NARCO  
UGR-2/2A GLIDESLOPE RECEIVER  
GENERAL INDEX

**MODIFICATION INSTRUCTIONS  
for  
UGR 2, 50 KHz KIT**

**KIT NO. 03502-0501**

**PURPOSE:** The NARCO UGR 2A is a slight modification of the UGR 2 Airborne ILS Glide Slope Receiver. It contains an additional 20 channels for a total of 40 Glide Slope channels. Primarily, the changes to the UGR 2 are the addition of a 2nd LFO Assembly and a shift of the intermediate frequency from 7.35 MHz to 7.50 MHz.

**FIGURE 1**

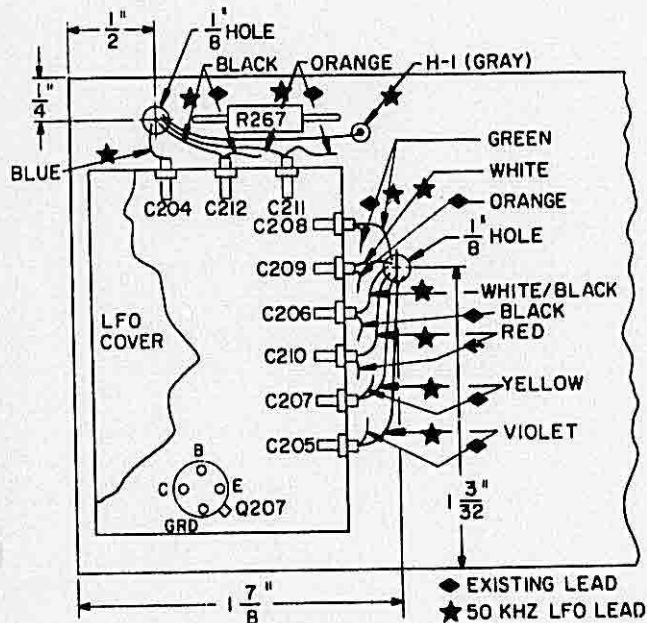
1. Remove UGR 2 from case.
2. Drill two  $\frac{1}{8}$ " holes in the matrix board at the points indicated in Figure 1. Use caution so as to avoid drilling thru track or wires.
3. Remove the red wire between C204 and the matrix board. (See Figure 2)

5. Feed the ten wires thru the holes in the matrix board and connect them to the feedthru capacitors and H-1 as shown in Figure 1.
6. Connect the coaxial cable center conductor to Q207's collector and solder the shield and the black wire to ground. (See Figure 4)

**FIGURE 3**

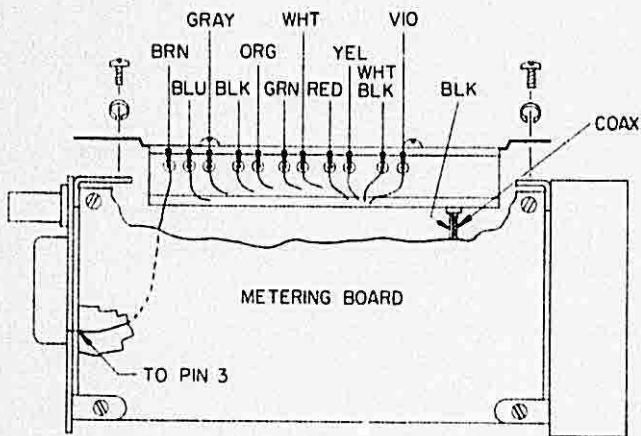
4. Install the new assembly, P/N 01166-0101, into the UGR 2 that is being modified. (See Figure 3)

7. Solder the BROWN wire to Pin 3 of the rear connector. (See Figure 3)

**FIGURE 4**

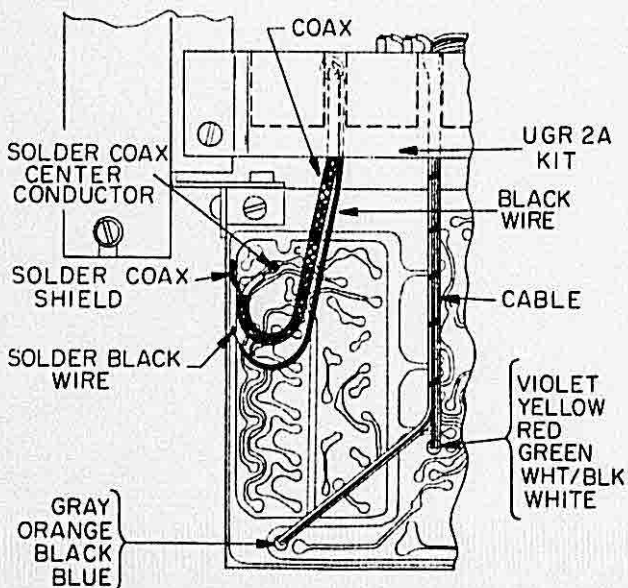
**CAUTION:** Route shield to avoid shorting to track!

**FIGURE 5**

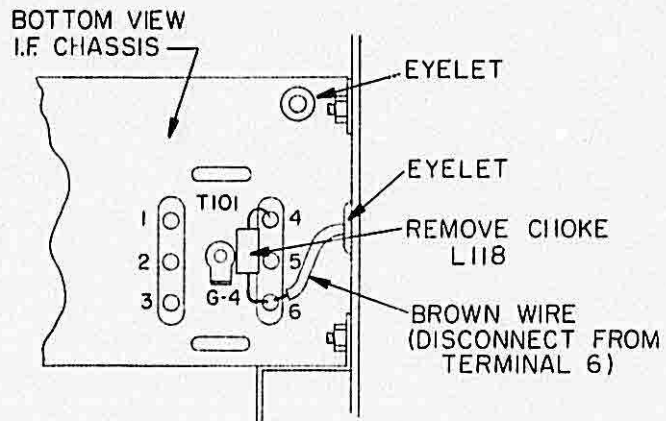
8. Clip out L118 from the UGR 2 and discard it. (See Figure 5) DO NOT CUT BROWN WIRE.

**FIGURE 6**

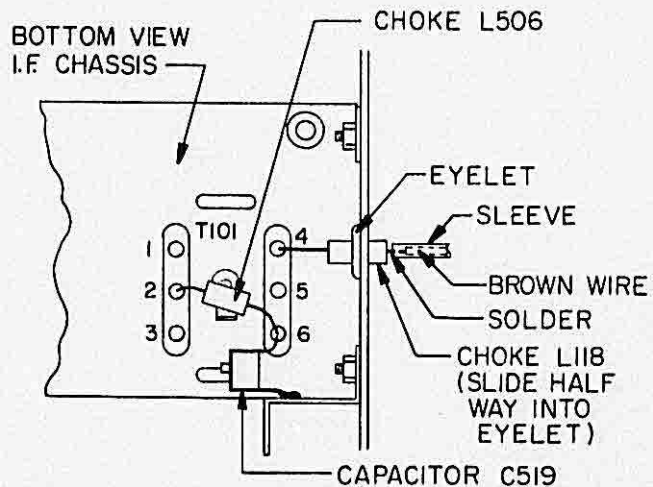
9. Cut one end of the new L118, P/N 11485-0009, (.47  $\mu$ h) to 3/16" from the body. Disconnect the brown wire from terminal 6 of T101. Slip a small piece of plastic sleeving onto the brown wire. Solder the 3/16" choke lead to the brown wire. Slip the sleeving over the joint. Carefully push the brown wire along with the sleeving and the choke into the eyelet until just half of the choke can be seen. (See Figure 6) Attach the exposed end of L118 to terminal 4 of T101. Dress the choke so that it comes straight out of the eyelet to T101.

10. Connect L506, P/N 11485-0001 (0.1 $\mu$ h) between T101, Pin 2 and T101, Pin 6. (See Figure 6)
11. Connect C519, P/N 22041-0004 (5-18pf) between T101, Pin 6 and the ground as shown. (See Figure 6).

FIGURE 7

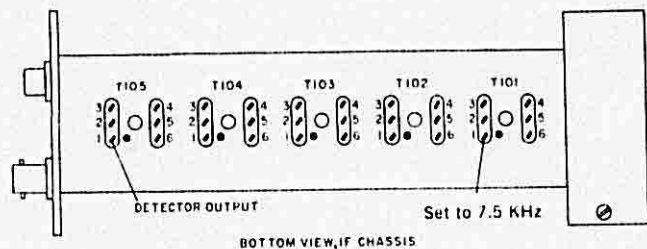
It is necessary to realign the intermediate frequency from 7.35 MHz to 7.5 MHz. This is accomplished as follows:

Refer to Figure 7.

1. Connect AC VTVM and oscilloscope to Terminal 1 of T105.
2. Connect the RF signal generator to the base of Q103 at Terminal 1 of T101 through a .01 mfd capacitor with a 47 ohm resistor to ground on the generator side of the capacitor. Set the generator to 7.5 MHz modulated 30% by 1000 Hz. Set the input voltage to 13.75 or 27.5 volts per cable wiring.
